JAMES A. FITZPATRICK NUCLEAR POWER PLANT

AMENDMENT TO FACILITY OPERATING LICENSE

Amendment No. 34
License No. DPR-59

ATTACHMENT TO LICENSE AMENDMENT NO. 34

*Responsible for Power Authority
Direction of Fire Protection Program
Figure 6.1-1

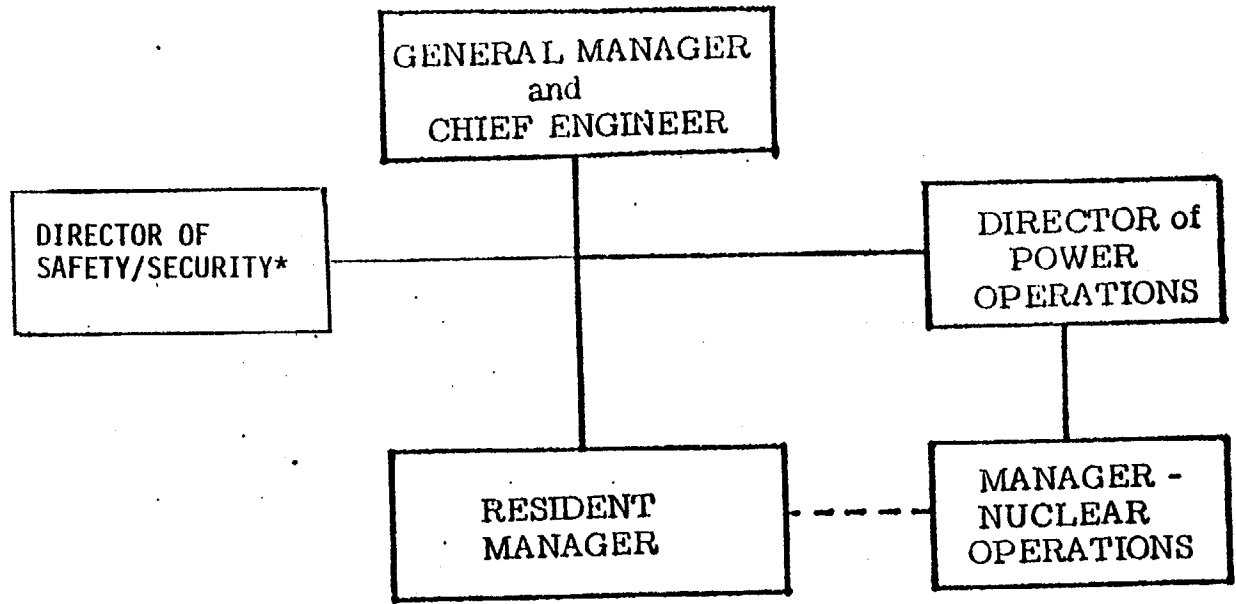
———— Administrative
----- Functional

FIGURE 6.2-1

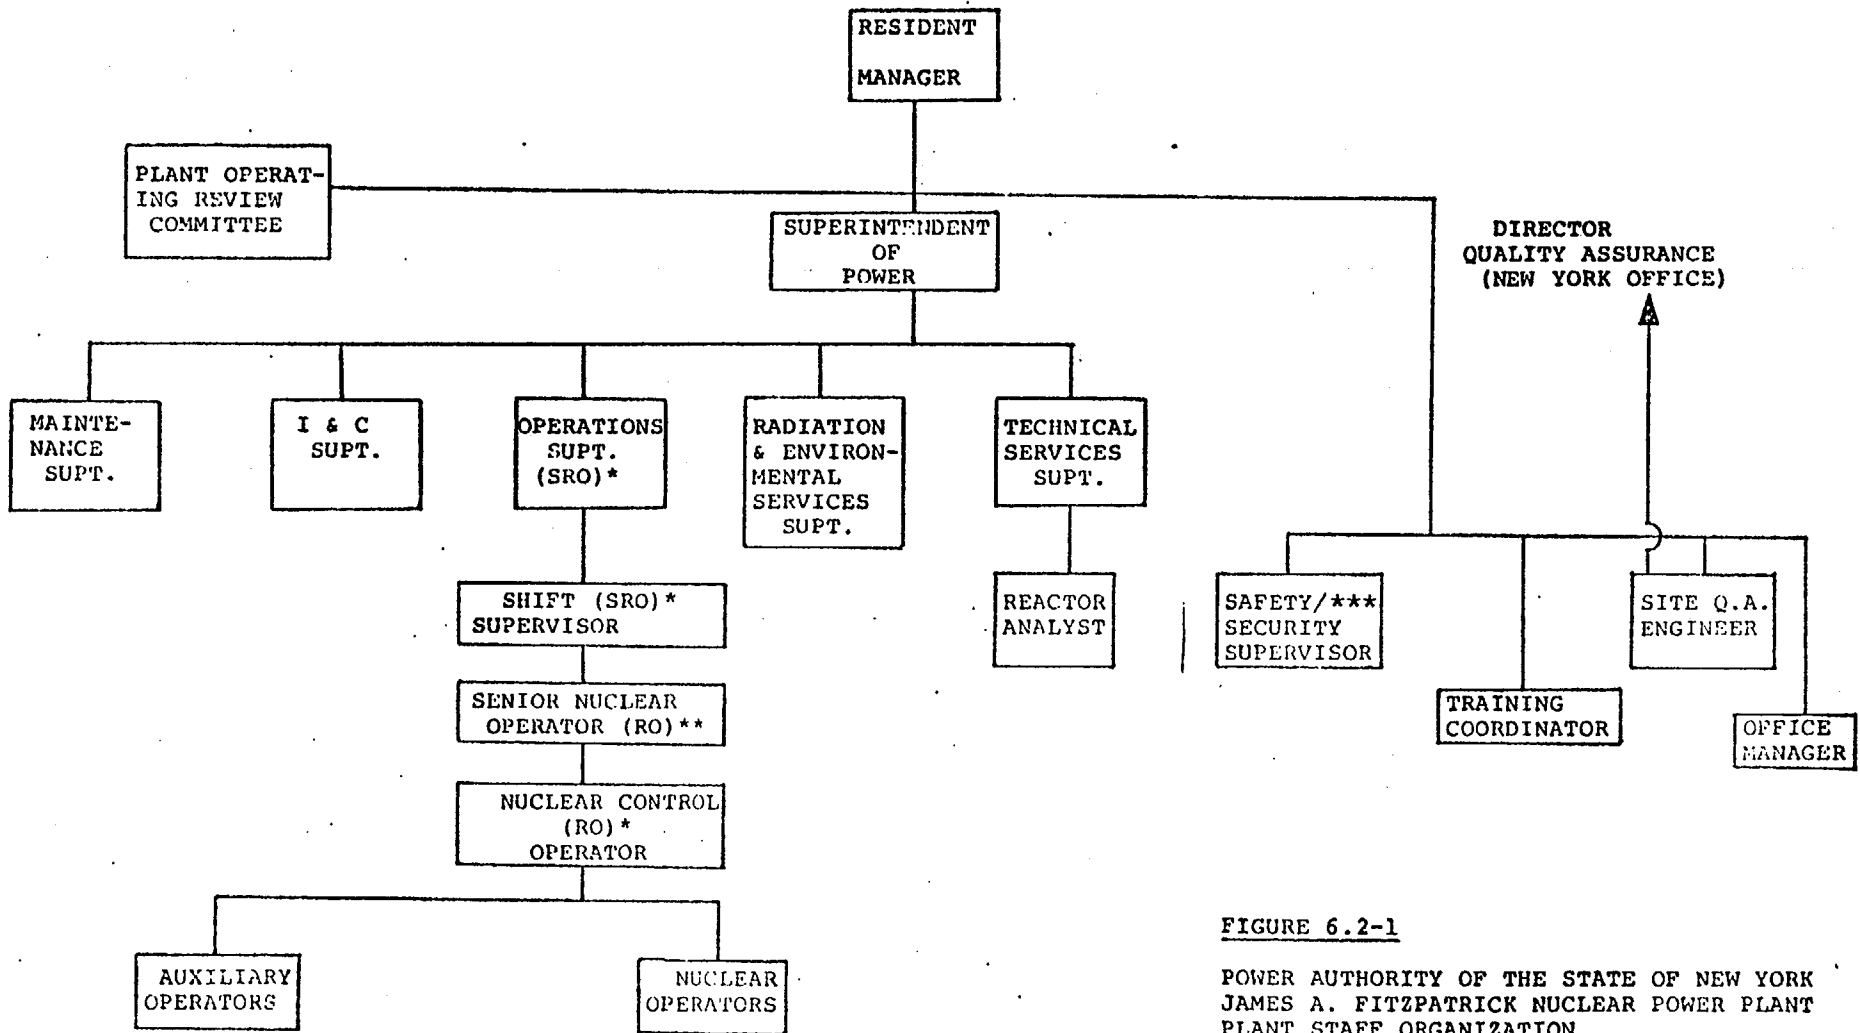
*** Responsible for J. A. FitzPatrick
 Fire Protection Program
